DOCUMENT 00 90 00
ADDENDUM

ADDENDUM: 1

DATE: APRIL 14, 2025

PROJECT: IOWA-GRANT SCHOOL DISTRICT
LOCKER ROOM RENOVATION
462 IOWA GRANT ROAD
LIVINGSTON, WISCONSIN 53554
PROJECT NO. 25007

Sheet Title: FIRST FLOOR LIGHTING PLAN

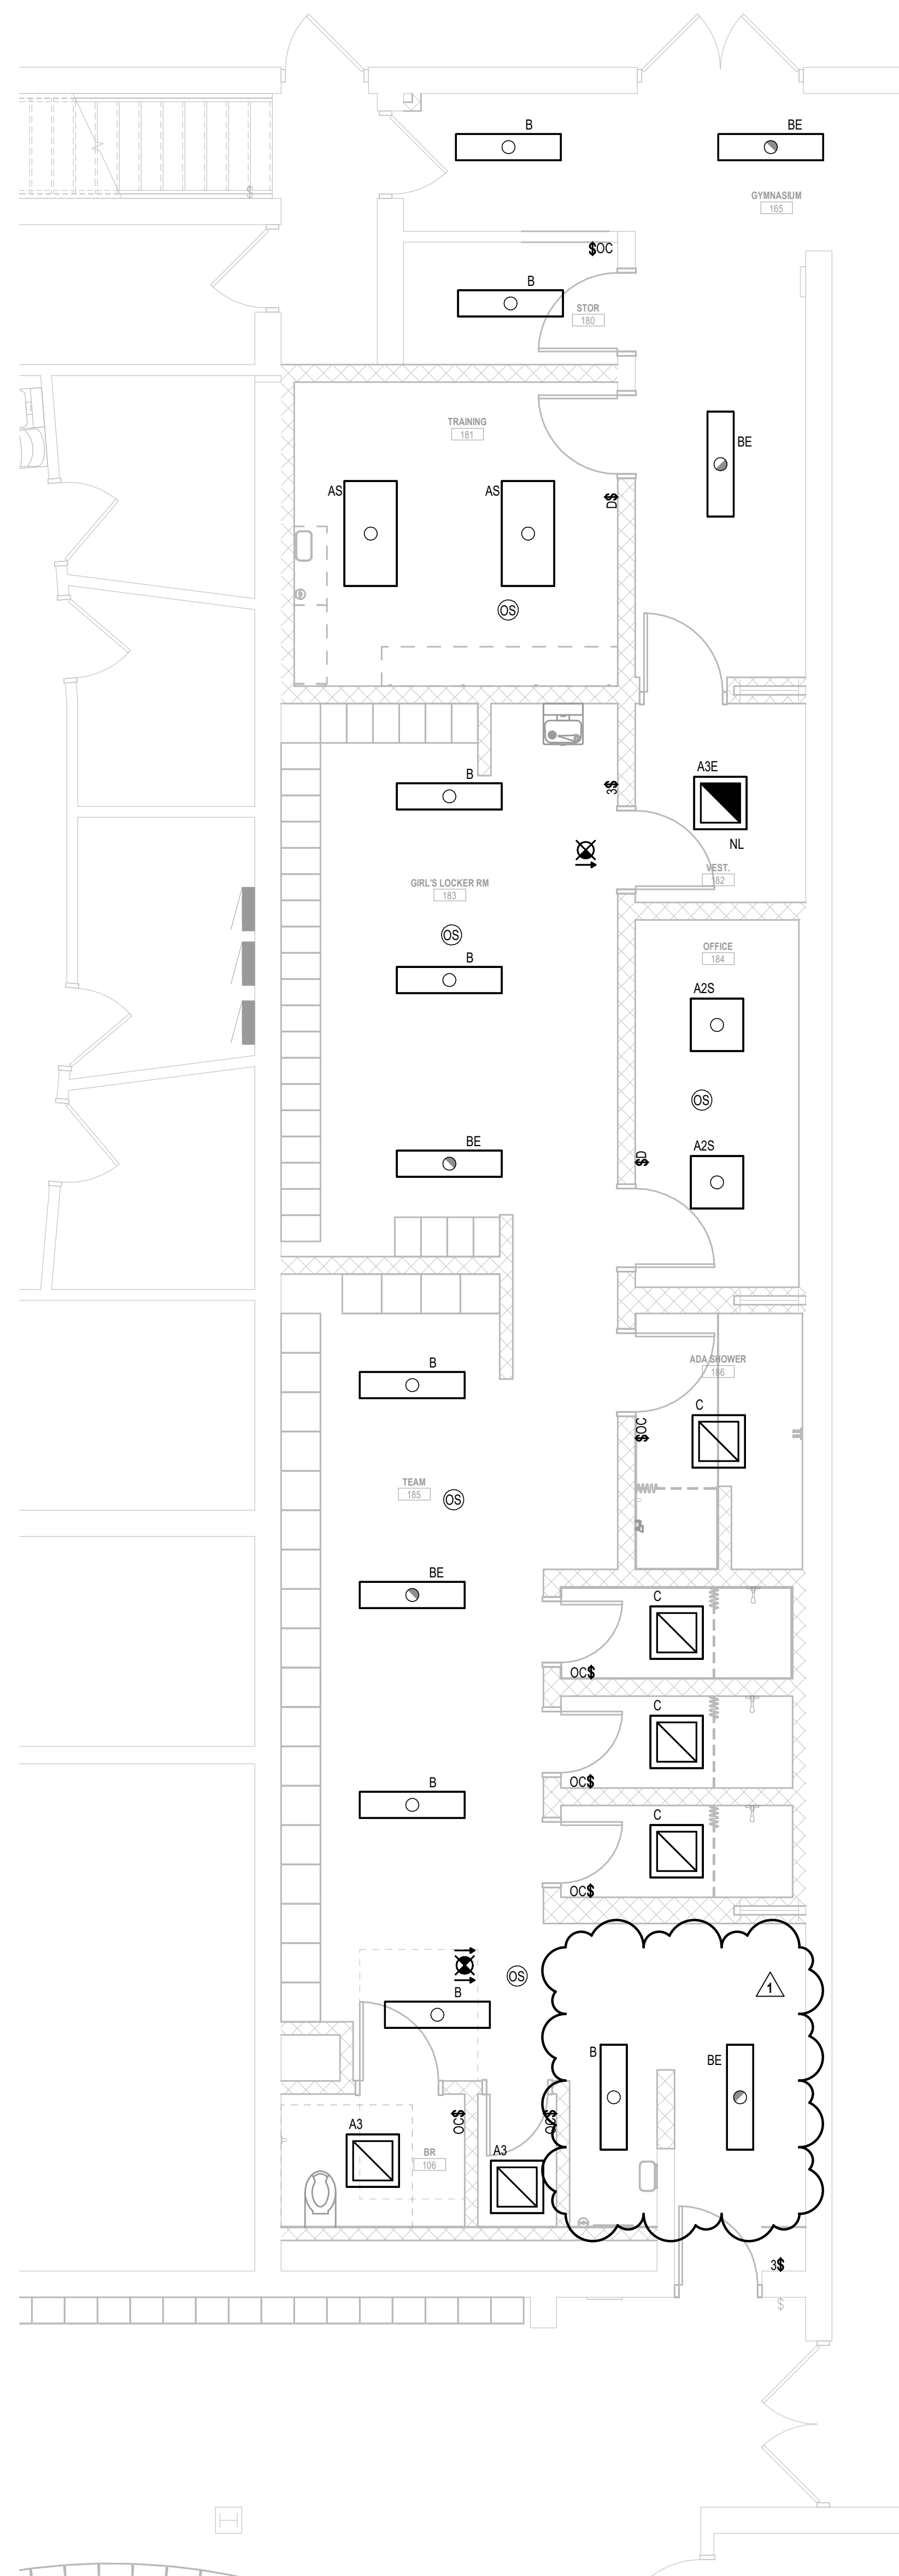
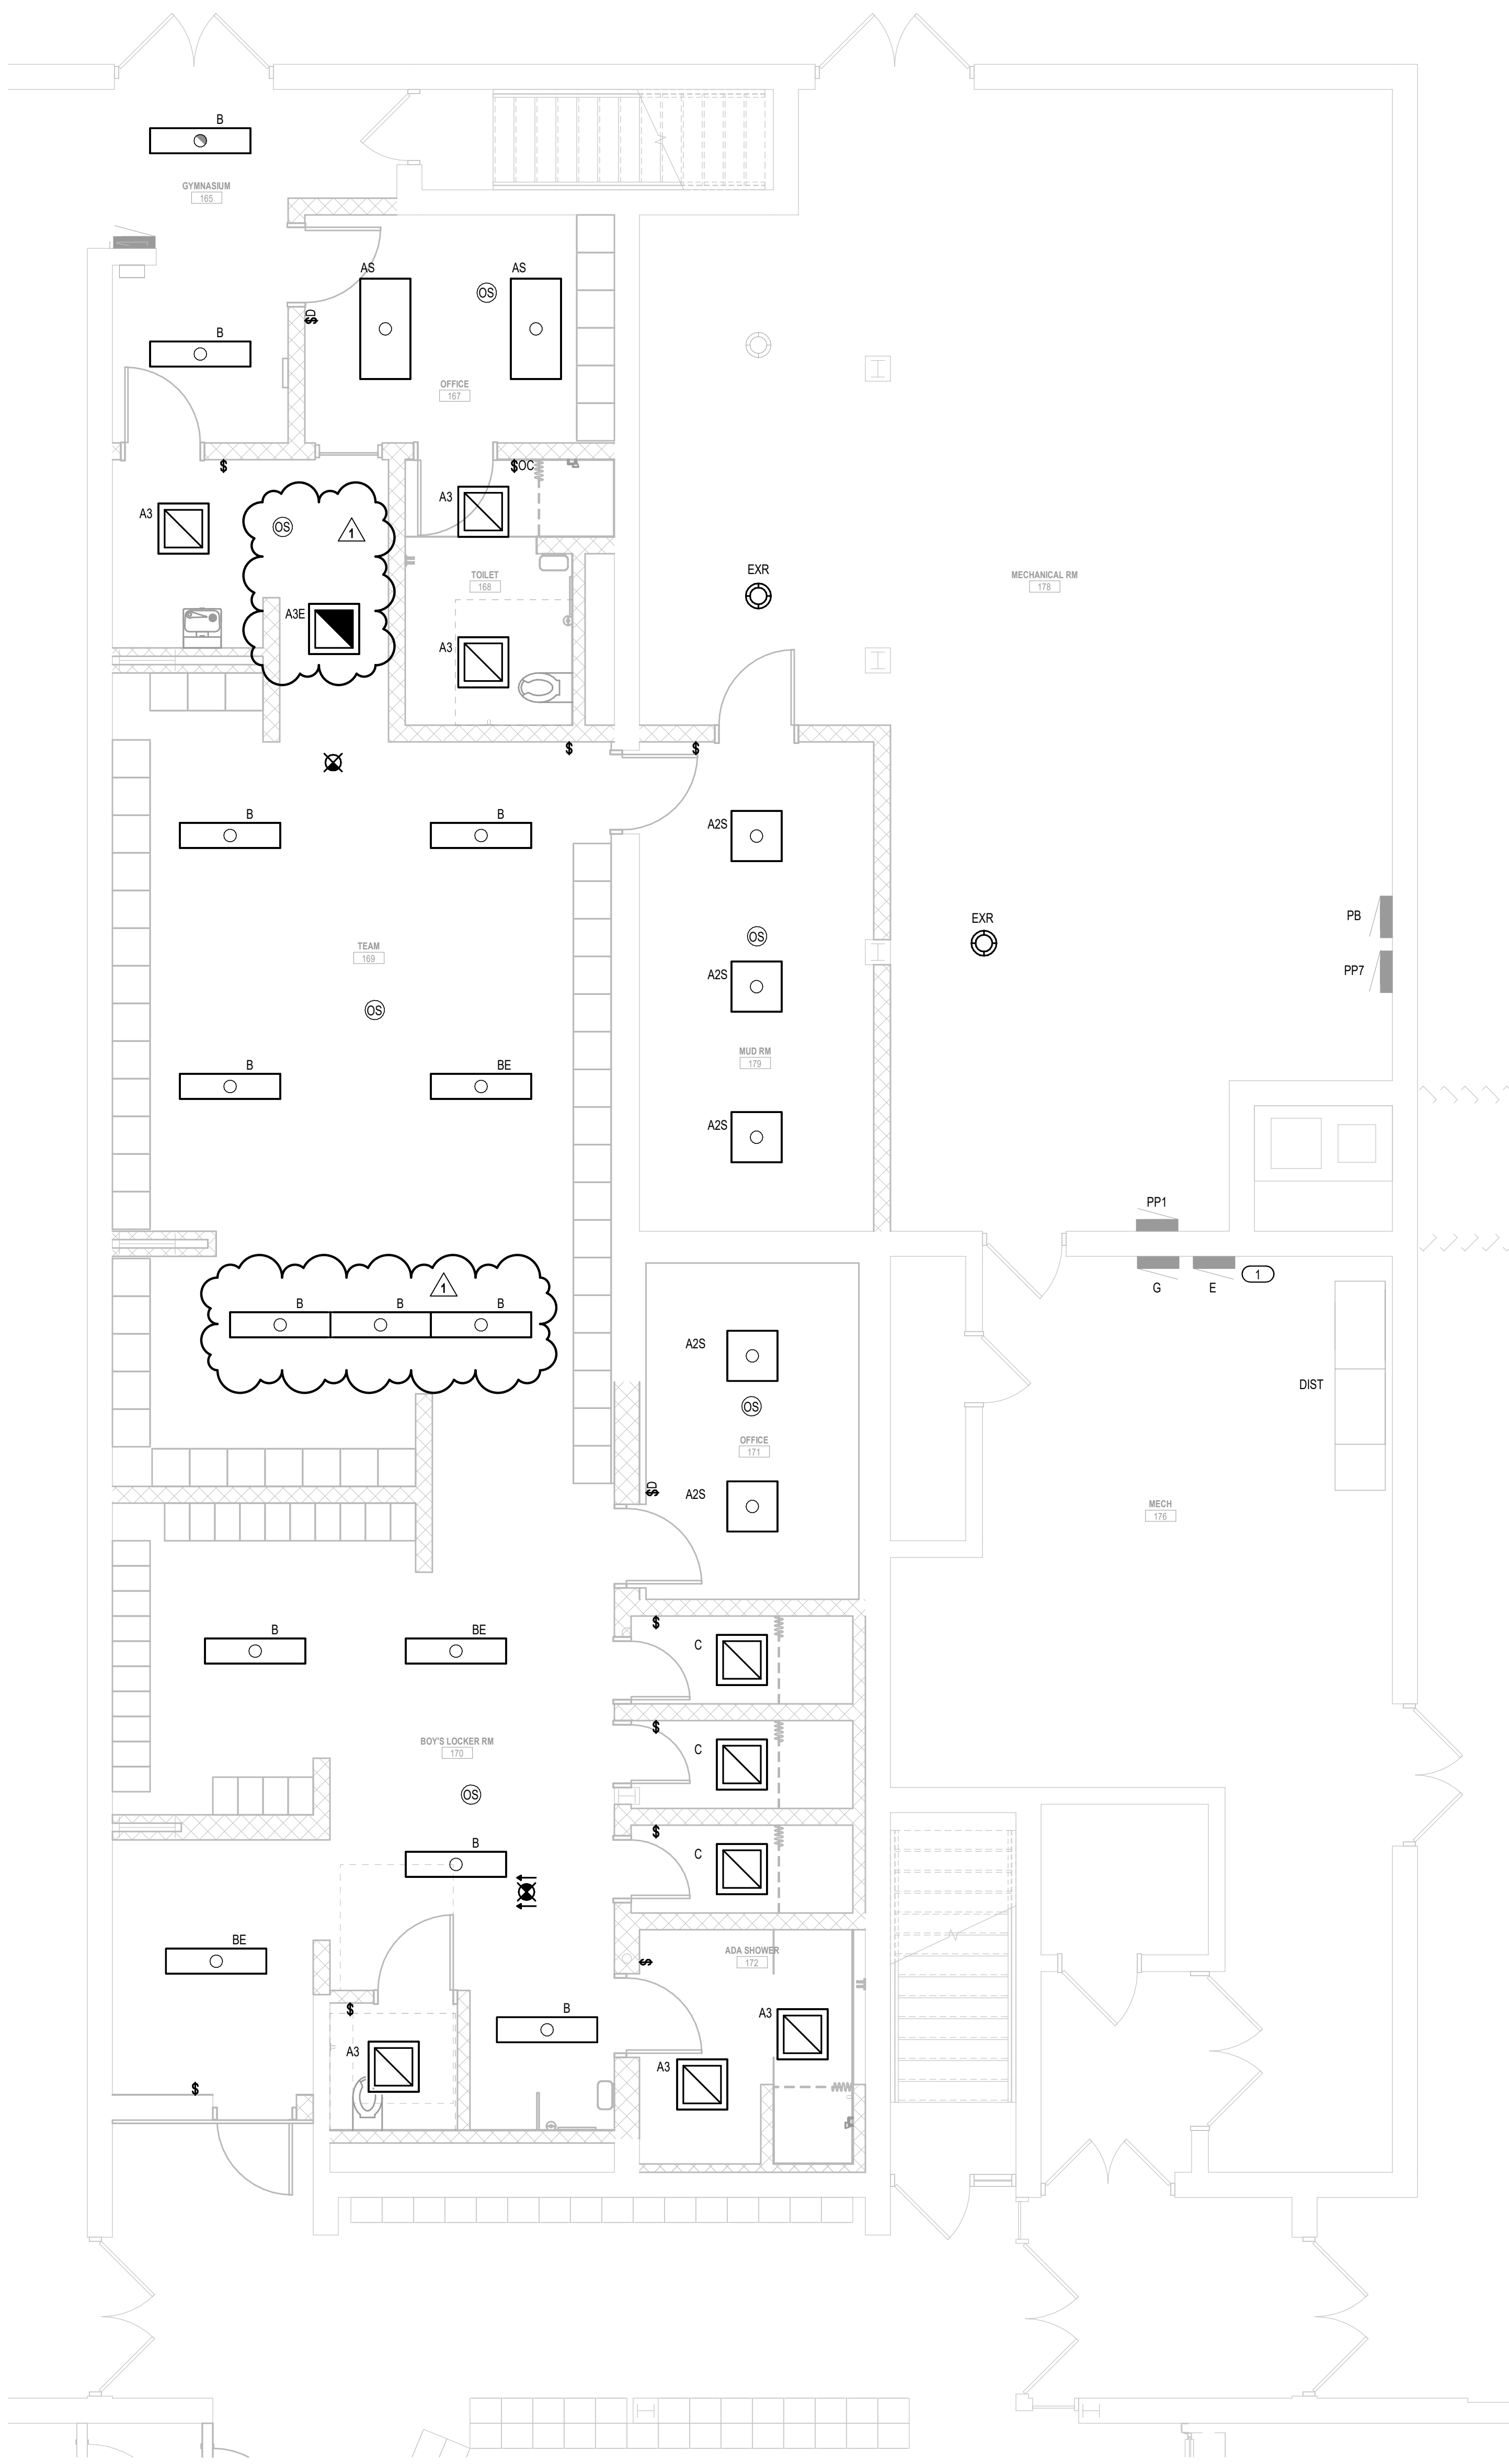
- a. See the revised sheet included in this addendum. Disregard the previous version.
 - b. Revise light layout.
 - c. Add light fixture.

IOWA-GRANT SCHOOL DISTRICT
LOCKER ROOM LAYOUT
462 IOWA GRANT ROAD
LIVINGSTON, WISCONSIN
FIRST FLOOR POWER & SYSTEMS PLAN

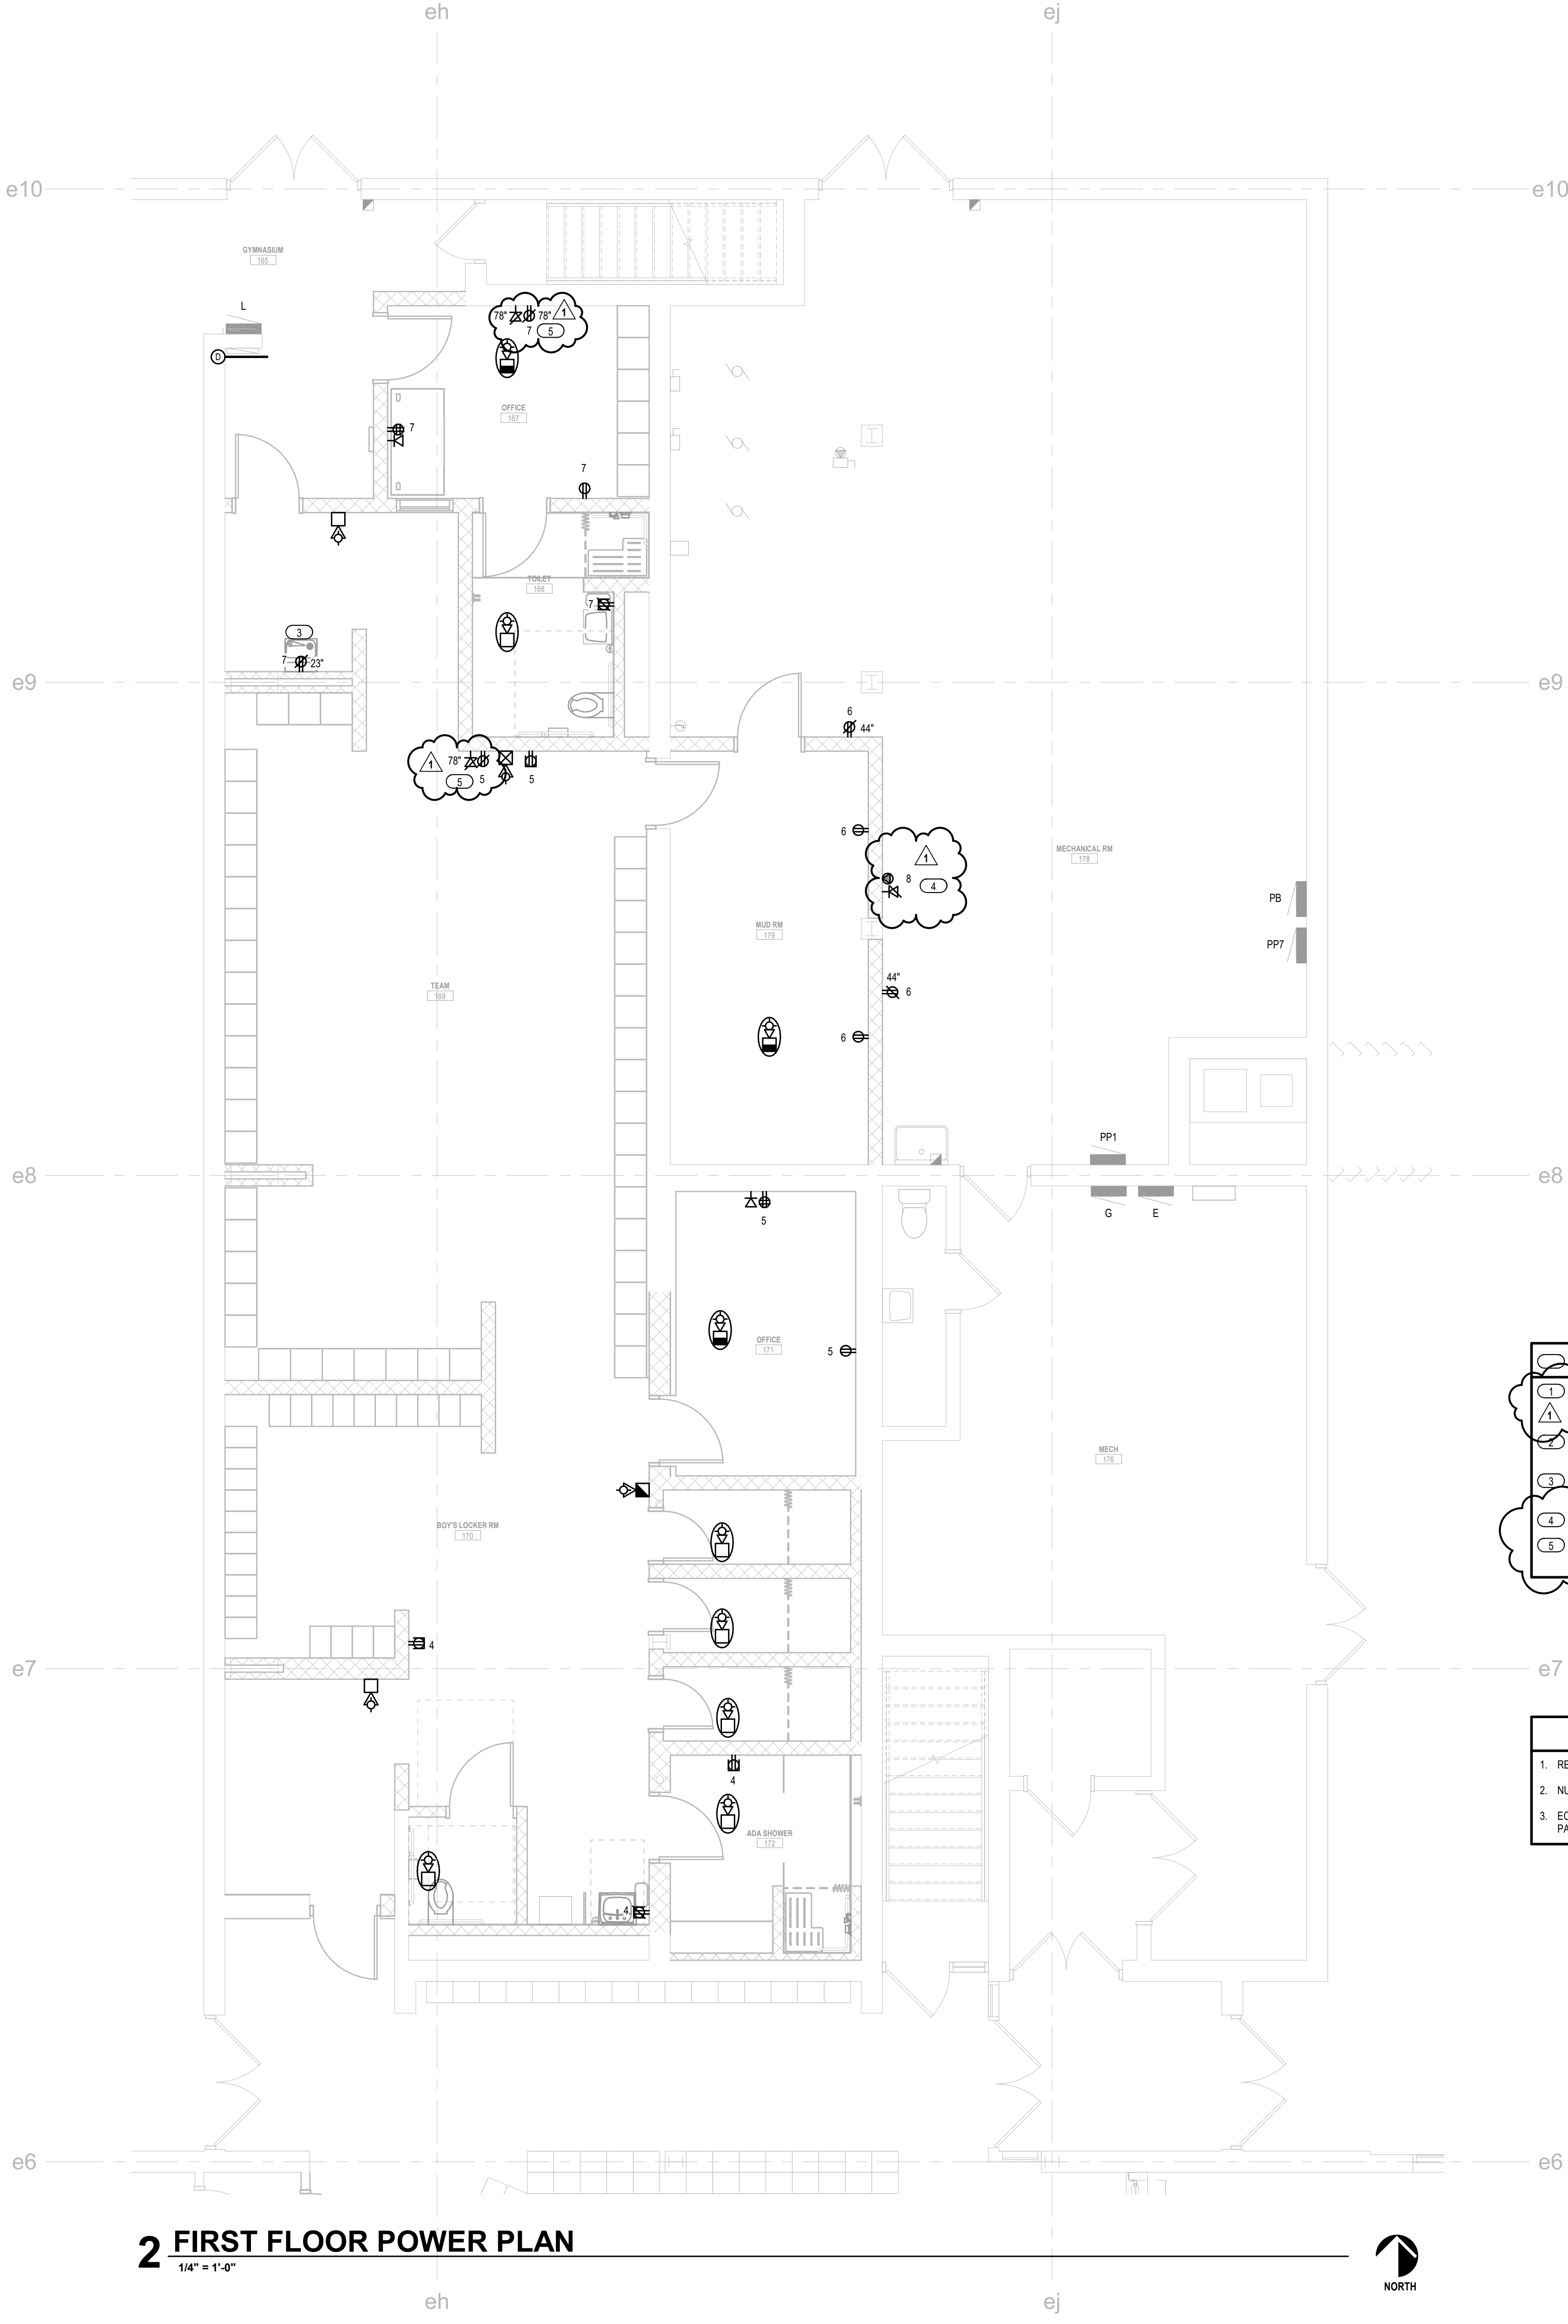
16. Sheet E121 FIRST FLOOR POWER & SYSTEMS PLAN 30"x42"
 - a. See the revised sheet included in this addendum. Disregard the previous version.
 - b. Revise location of control panel.
 - c. Add scoreboard repeaters.
17. Sheet E212 SECOND FLOOR ELECTRICAL PLAN 30"x42"
 - a. See the revised sheet included in this addendum. Disregard the previous version.
 - b. Revise location of control panel.
 - c. Demo / Add bell and speaker.
